RCSC Middle School **Natatorium HVAC & Lighting Upgrade**

Project # 2023.0011

05-20-2024

ADDENDUM NO. 01

TITLE
Building
Sections and
Elevations
SHEET

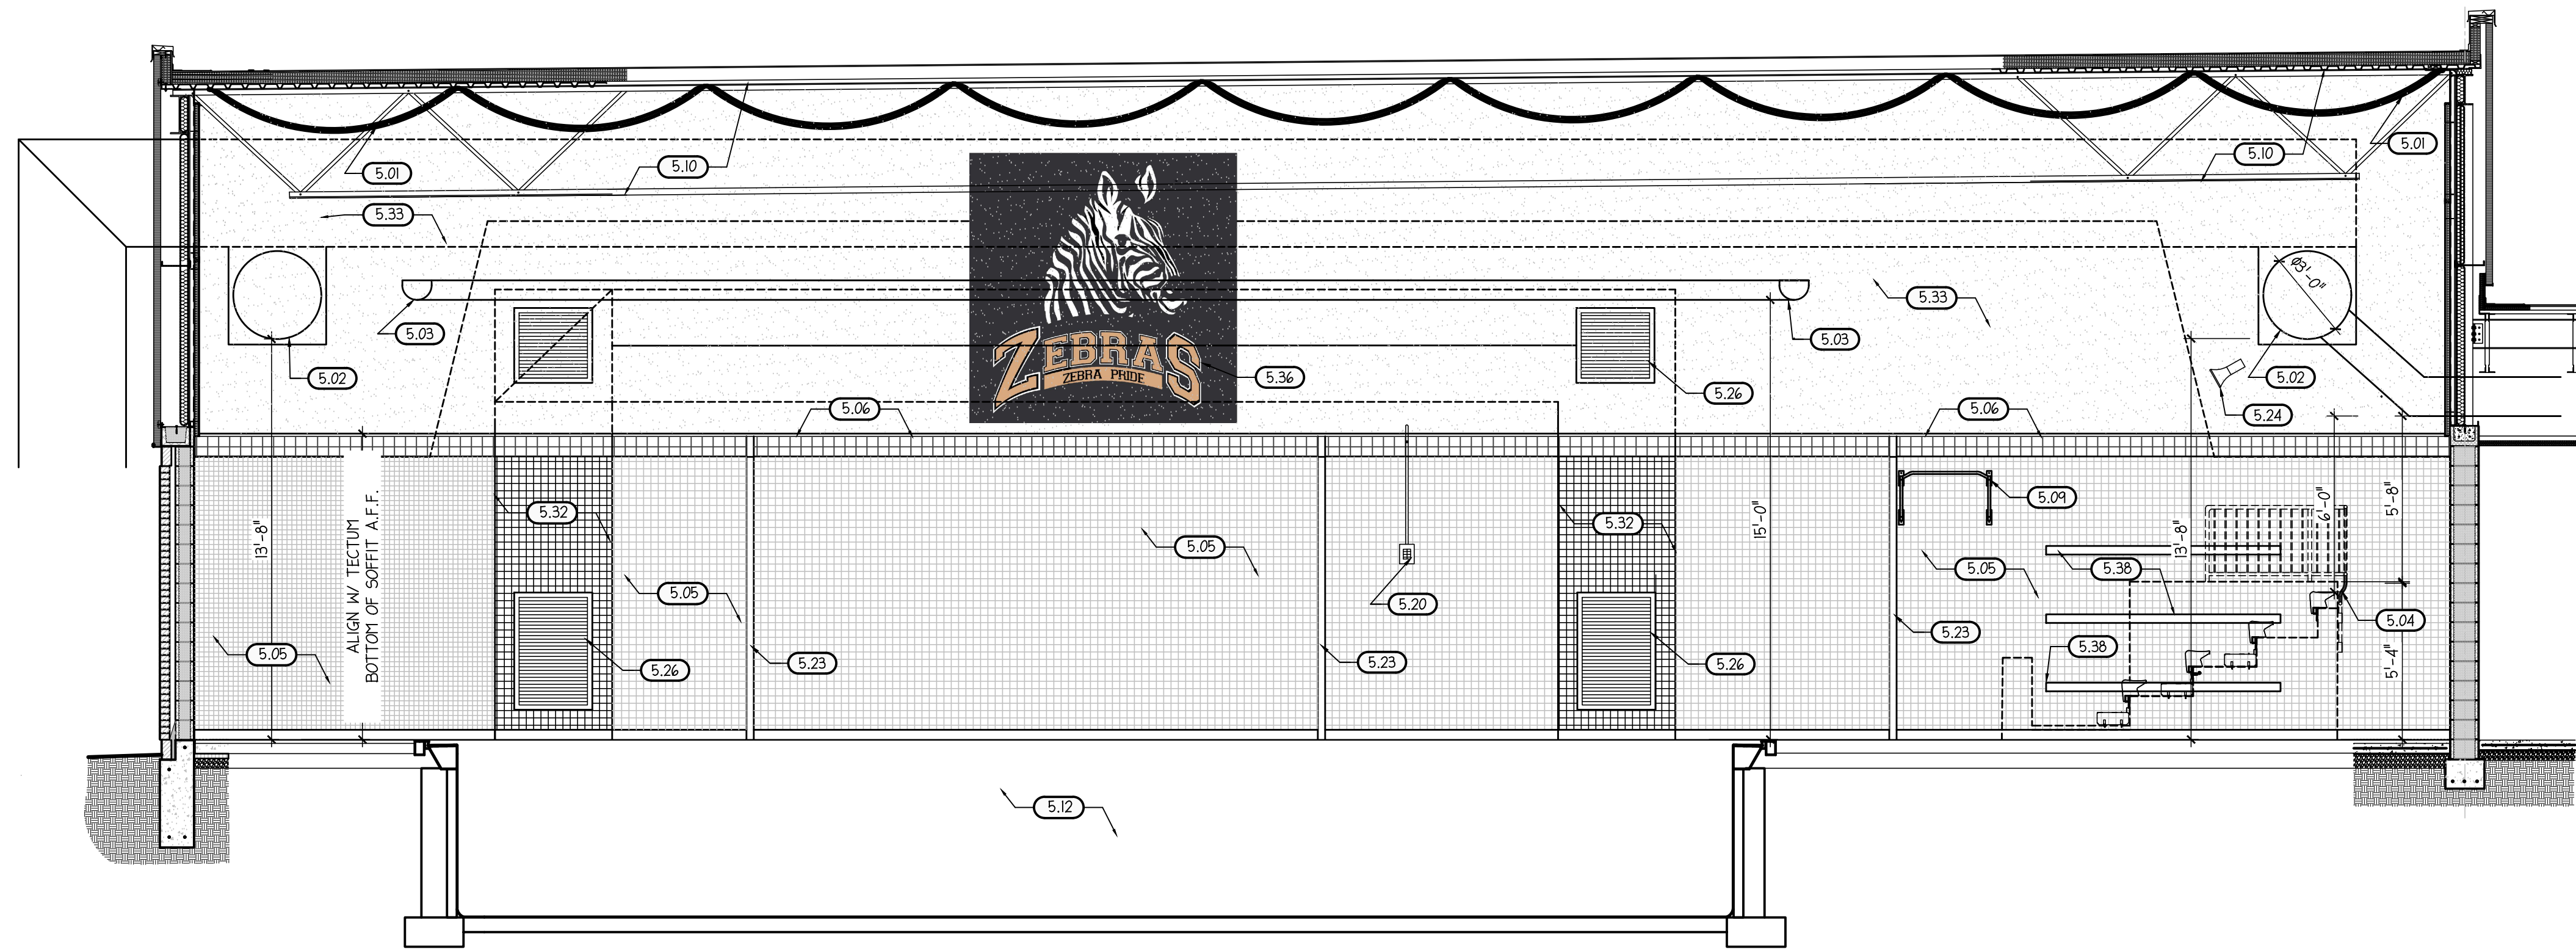
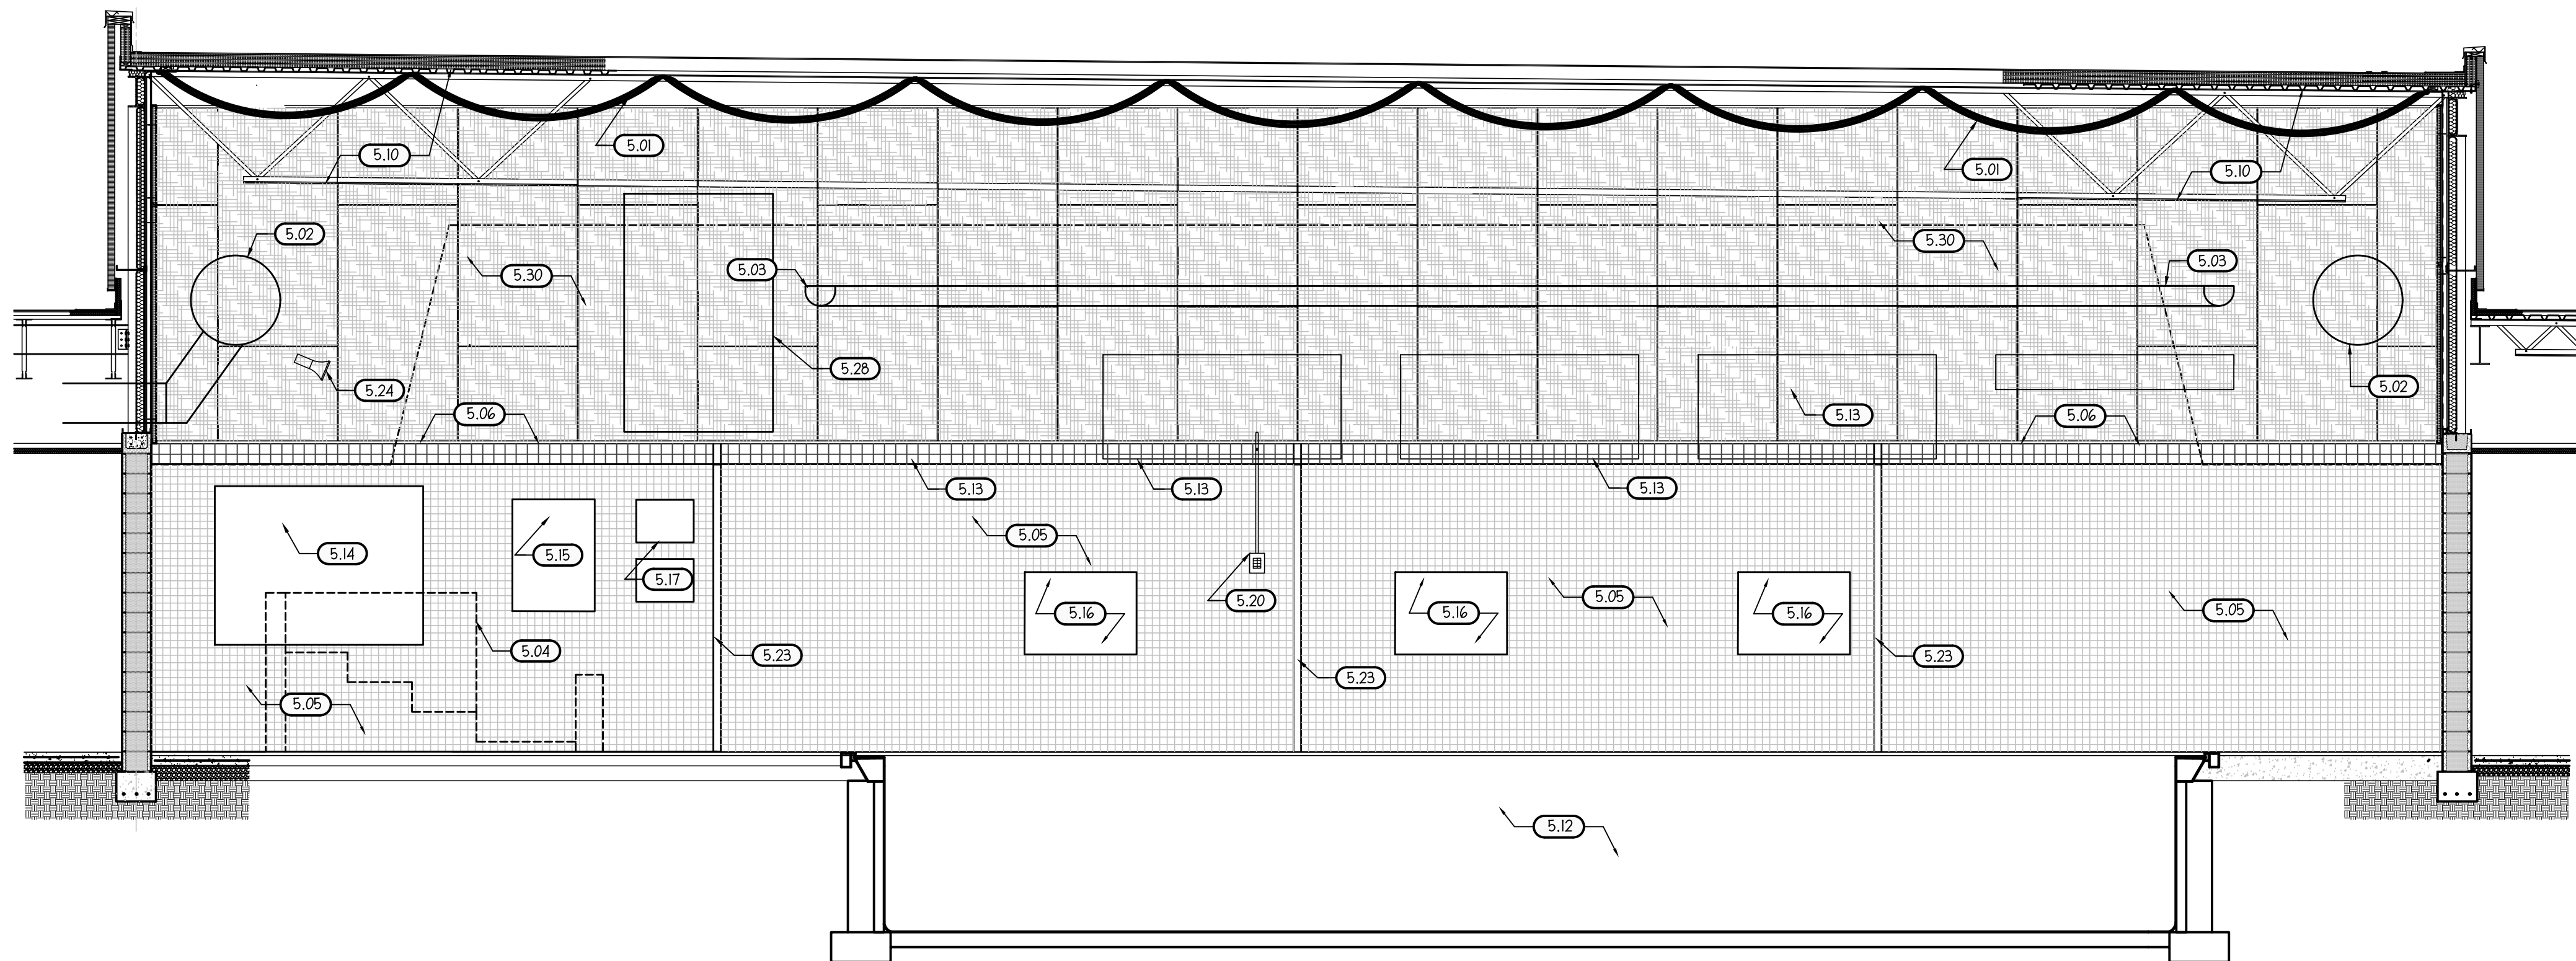
Location: A5.1 Building Sections and Elevations

1. Added Notes 5.36 to 5.38
2. Updated Notes 5.03, 5.06, 5.13, 5.30, 5.31, 5.32
3. Updated colors for Tectum Panels and added legend.

TITLE
Building
Sections and
Elevations
SHEET

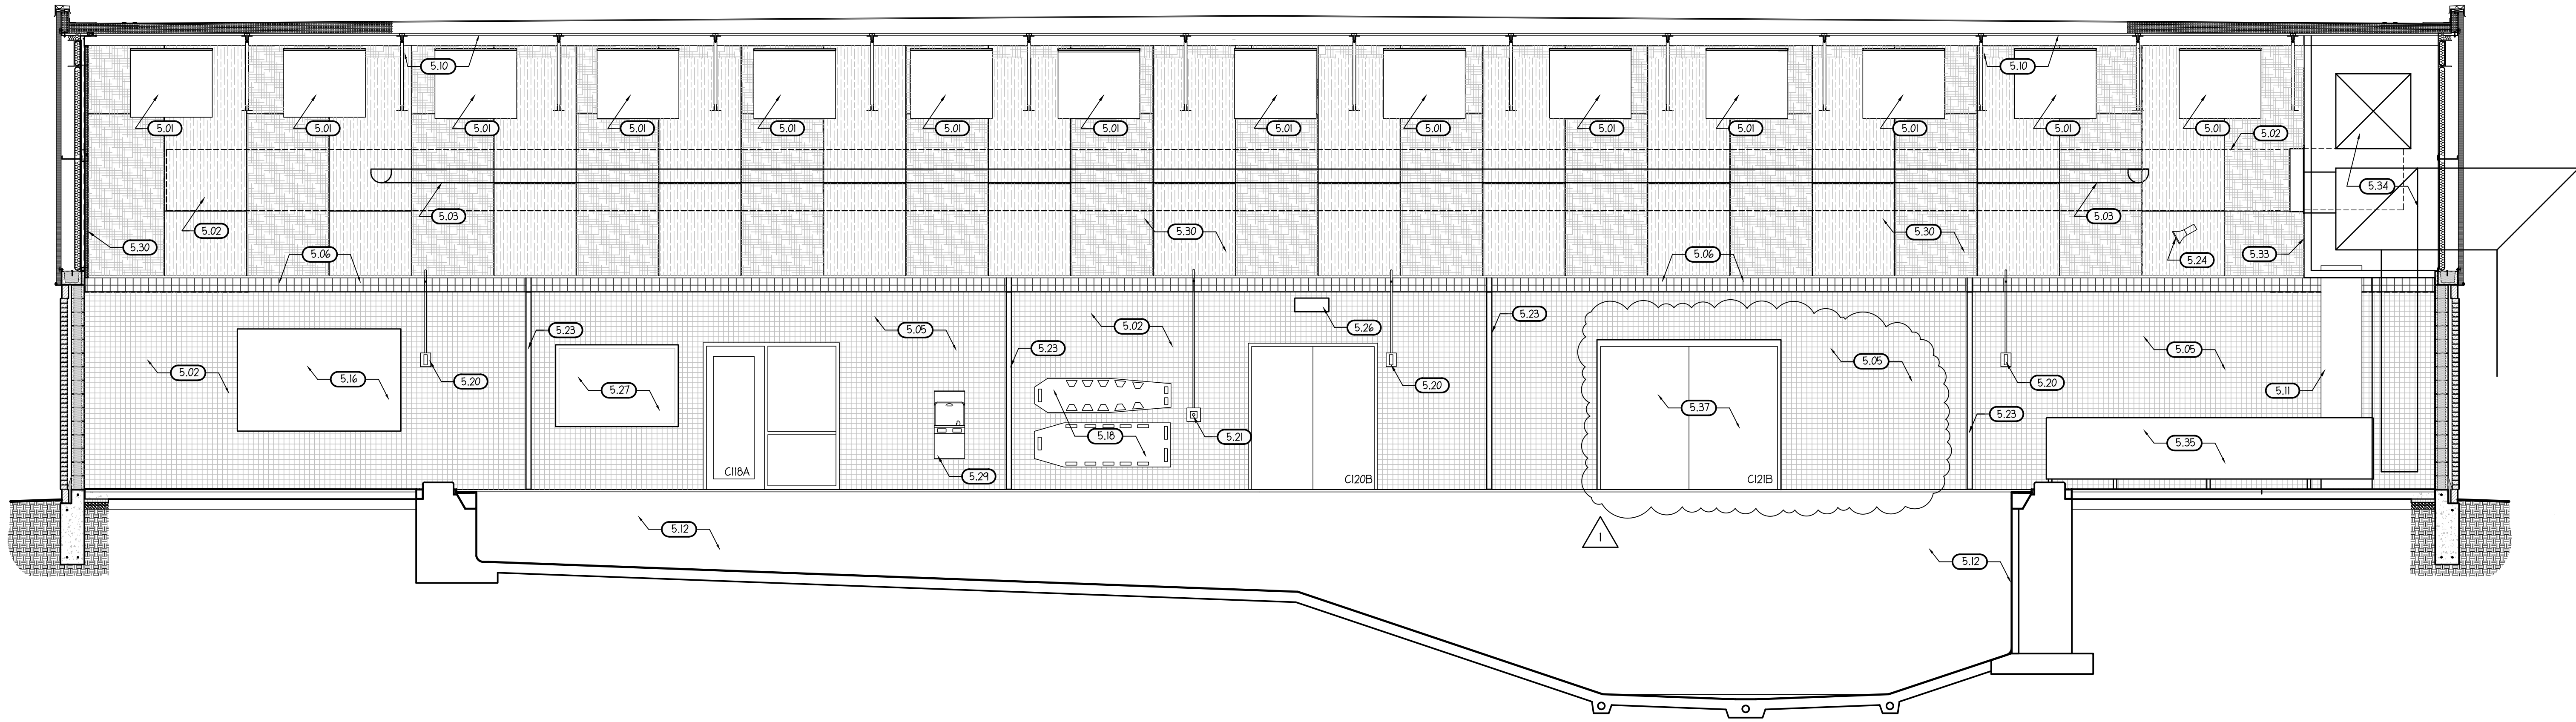
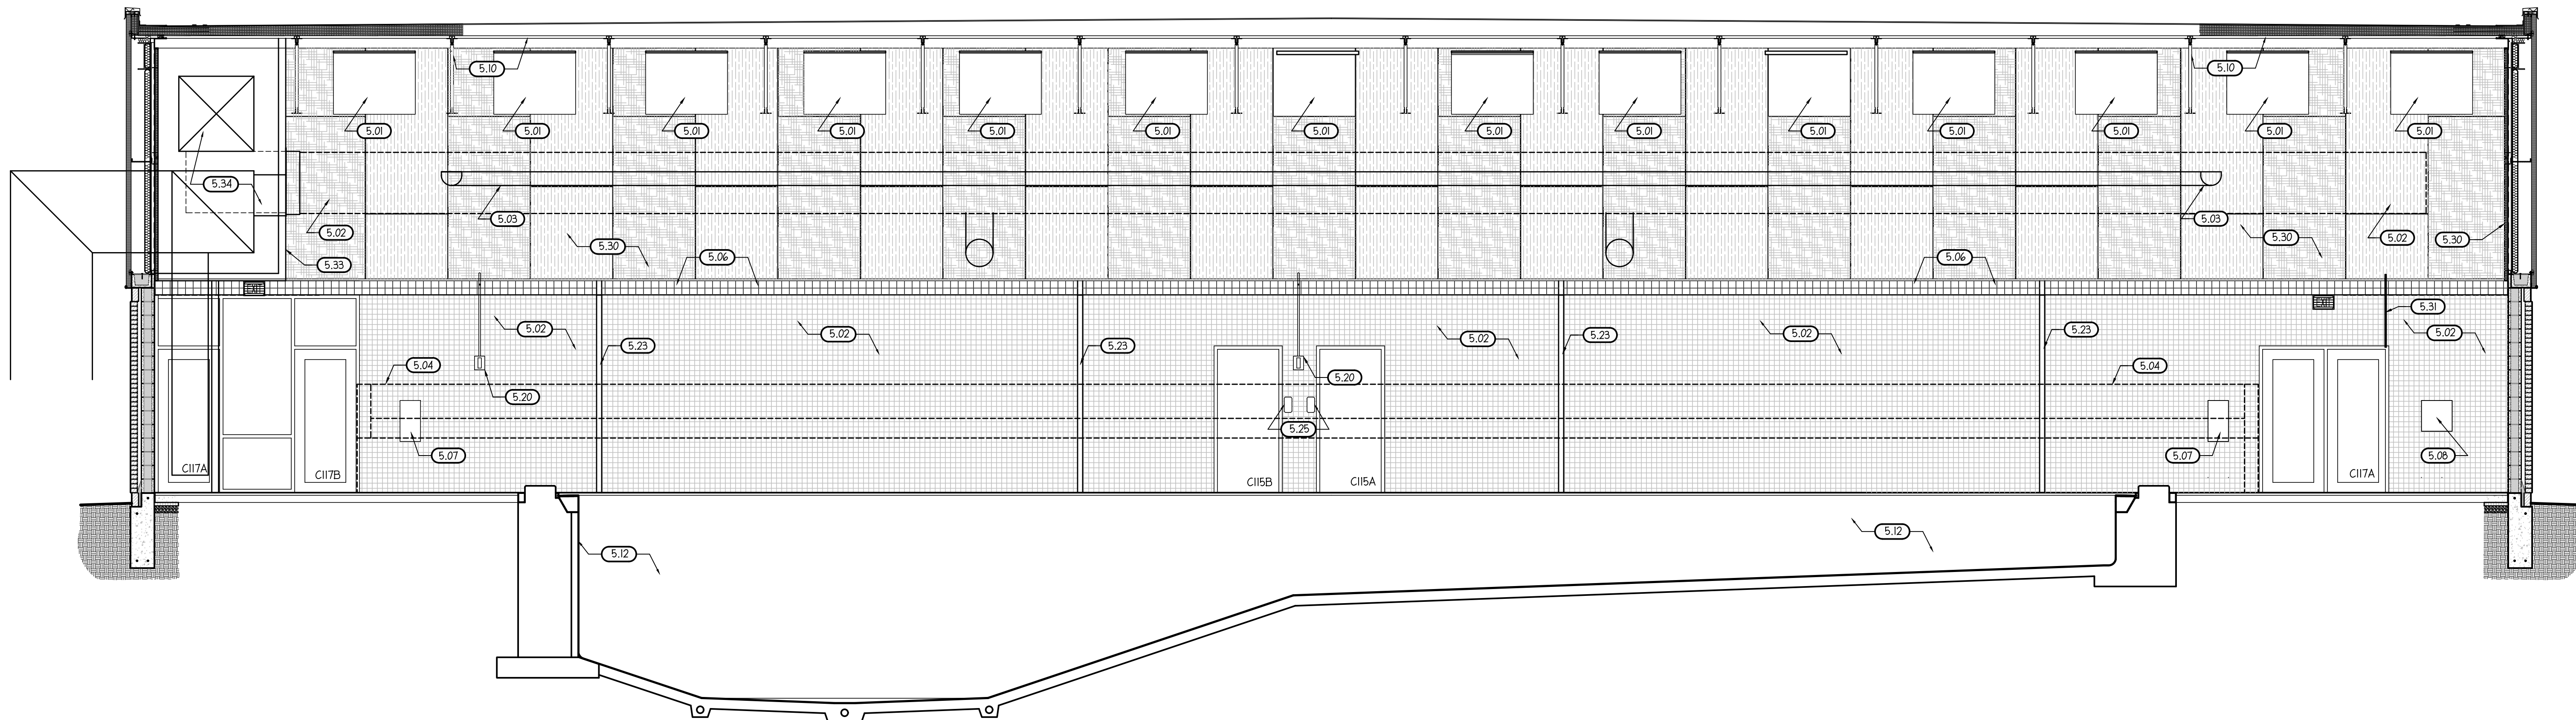
Location: A5.2 Building Sections and Elevations

1. Added Notes 5.36 to 5.38
2. Updated Notes 5.03, 5.06, 5.13, 5.30, 5.31, 5.32
3. Updated location of Backboards and Bulletin Board, with shift of Door C121B.
4. Updated colors for Tectum panels and added legend.

7 FLOOR TRANSITION

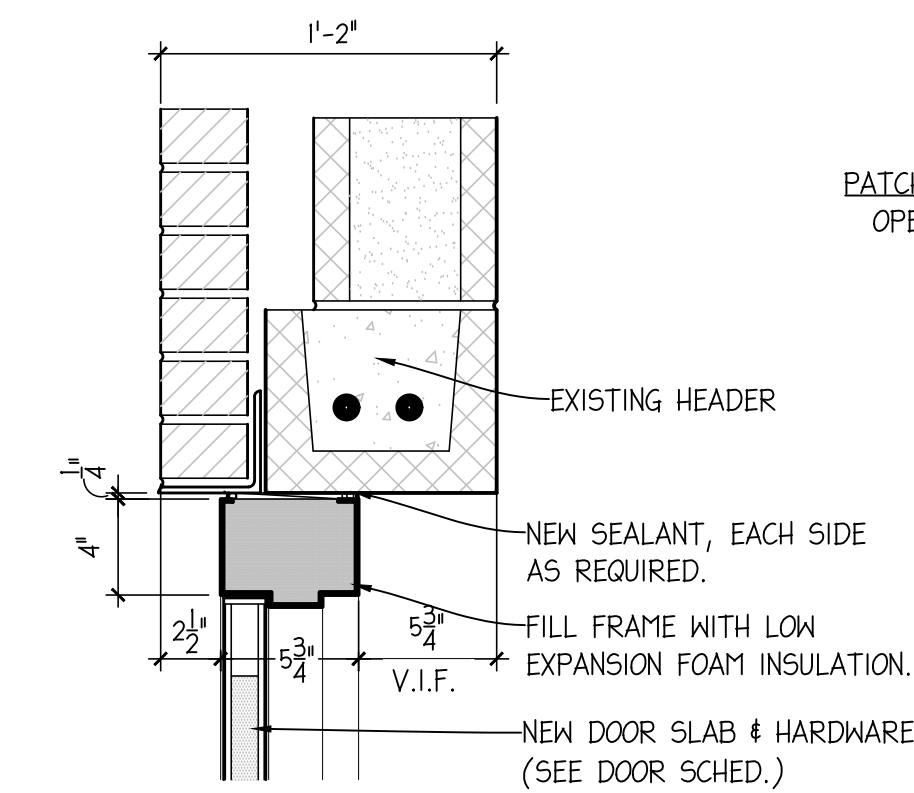
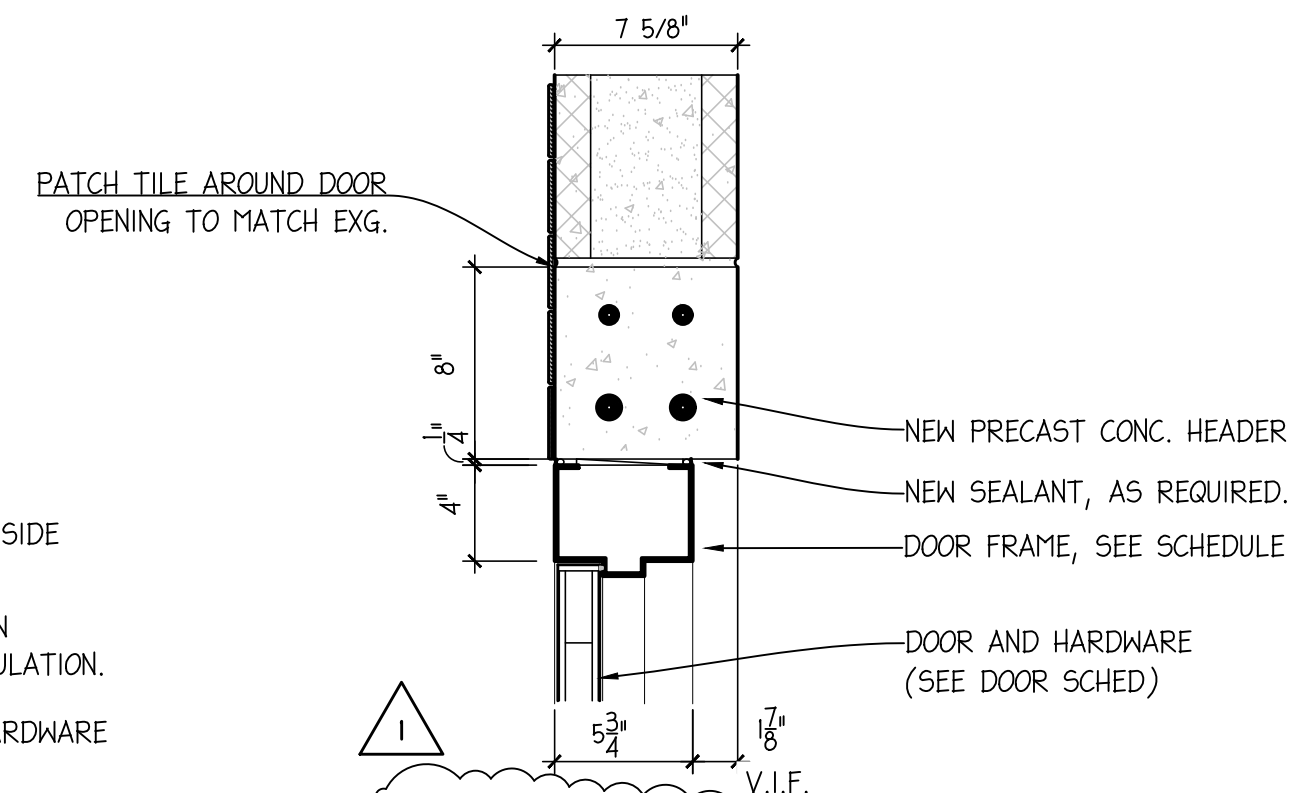
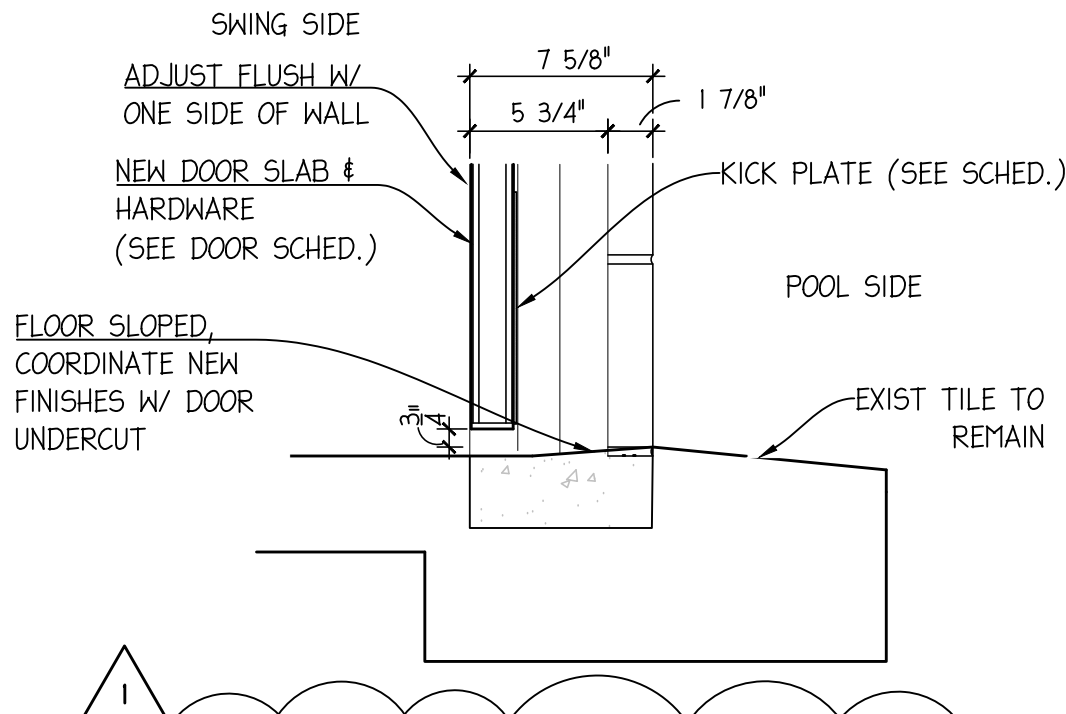
Item: **A-1.7**
Location: A7.1 Door Schedule and Details
Description: Replace drawing dated 05-01-2024 with drawing marked Addendum 01, dated 5-20-2024

1. Updated Details 1 / A7.1, 4 / A7.1.
2. Deleted details for continuous hinge and knuckle hinge.
3. Added Detail 7 / A7.1
4. Revised Door Schedule Notes and Remarks.
5. Updated Door Hardware set numbers to correspond with Updated Specification.
